Staff Report

Meeting Date: February 27, 2020 (Prepared February 20)

Item: 1785 N. Front Street “Woodburn High School” (CU 2019-07, DR 2019-13, EXCP 2019-07, & PP 2019-03)

OVERALL LANDSCAPE SITE PLAN - CONDITIONAL USE

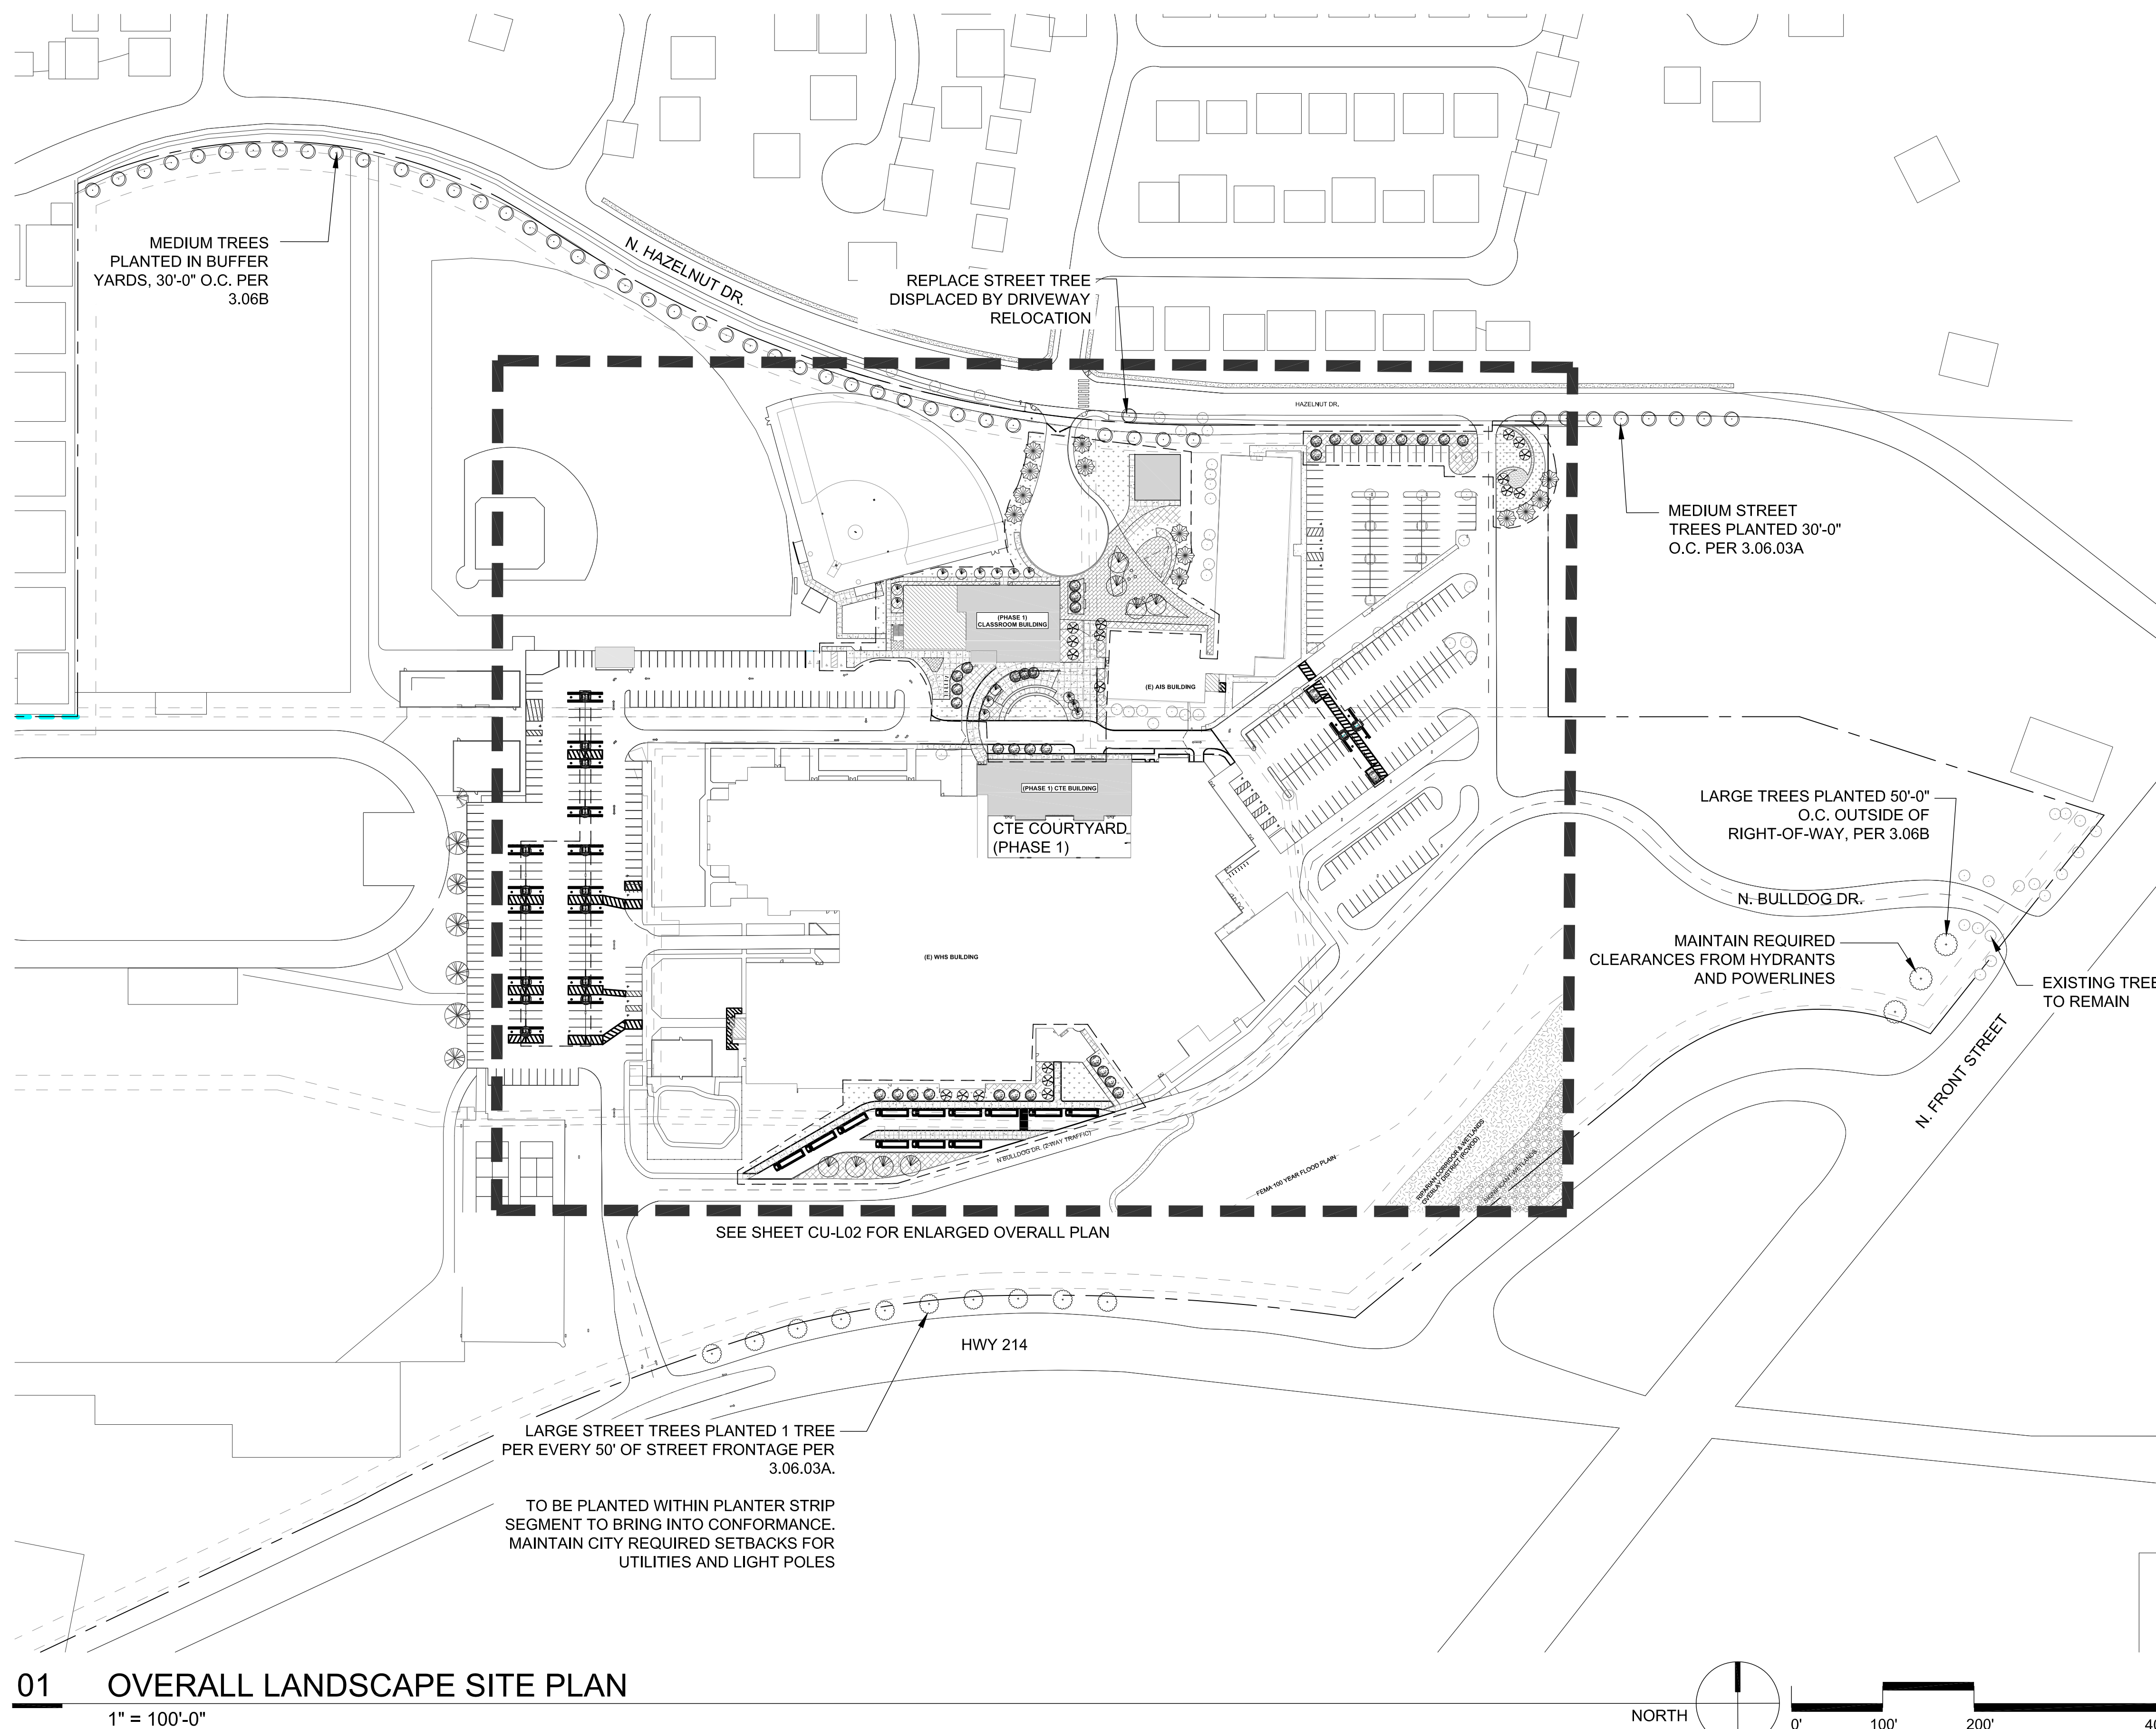
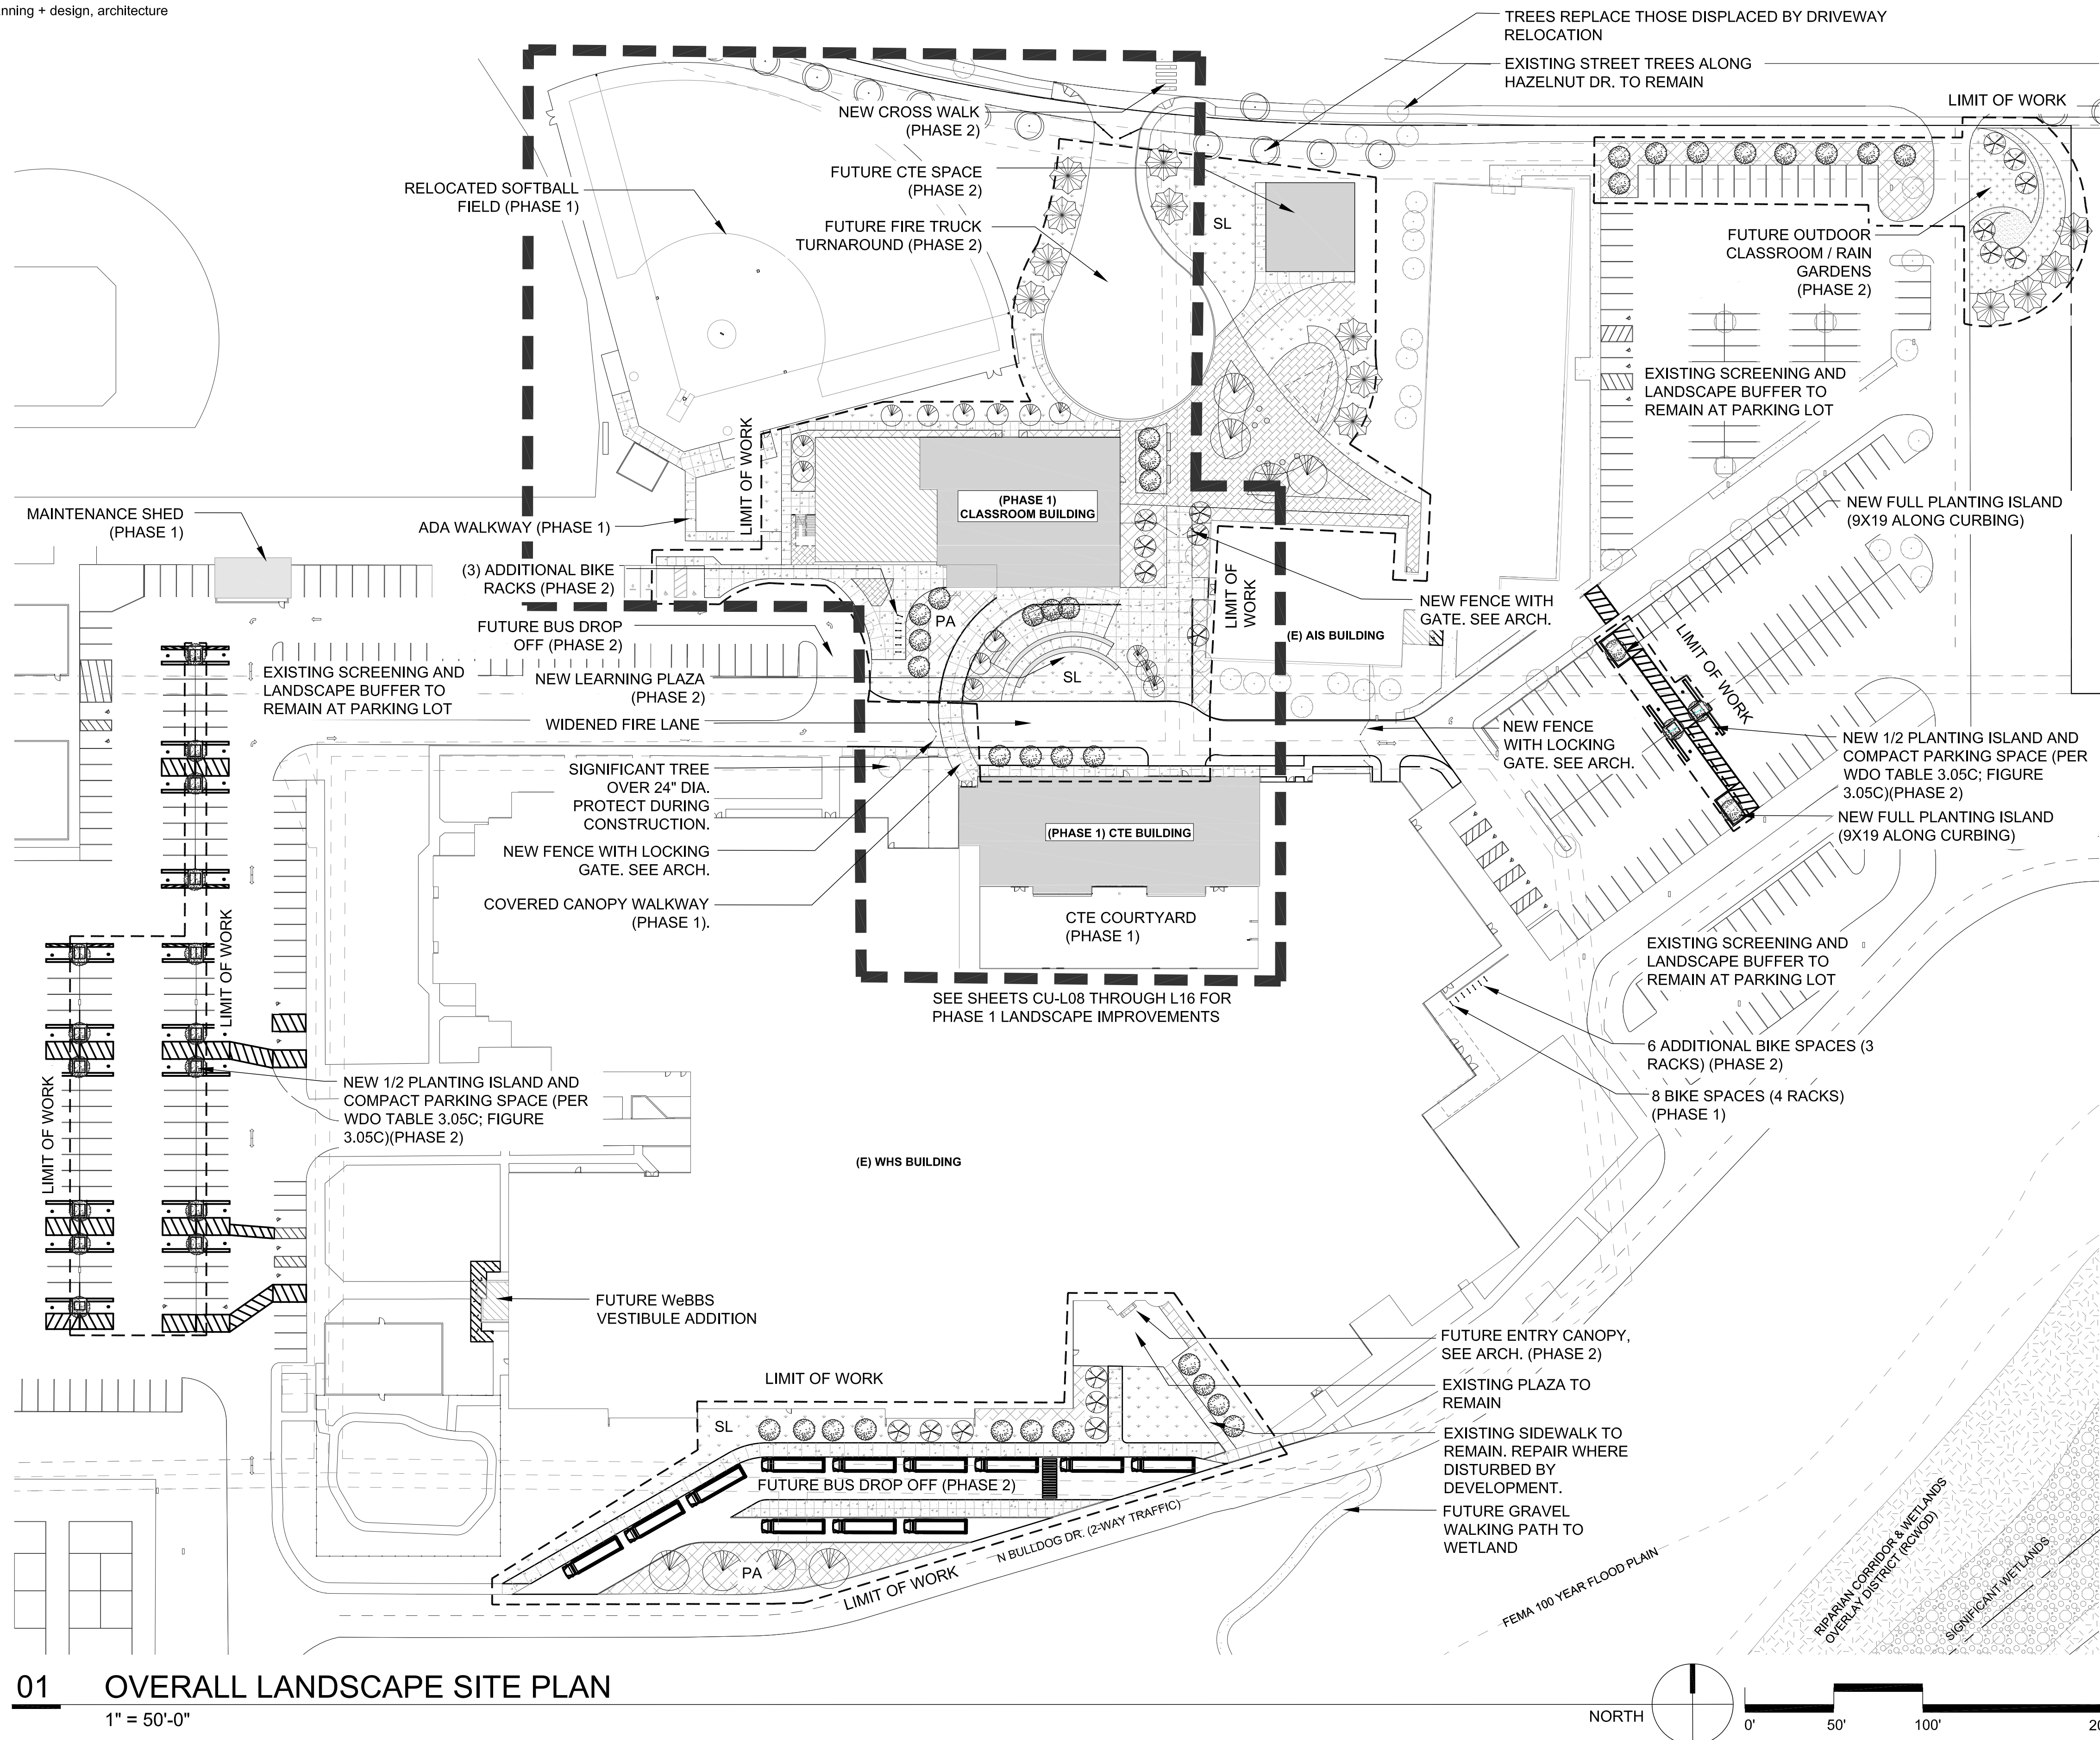
D3. Screening of parking: To meet WDO 3.06.05B, the applicant shall screen surface parking in the north yard from Hazelnut Drive. The applicant shall revise Sheet CU-L02 to clarify that proposed shrubbery amid the row of trees would be evergreen shrubbery forming a screen hedge or row as a vertical visual screen, growing to a minimum height at maturity of three-and-a-half (3½) feet from the abutting street grade.
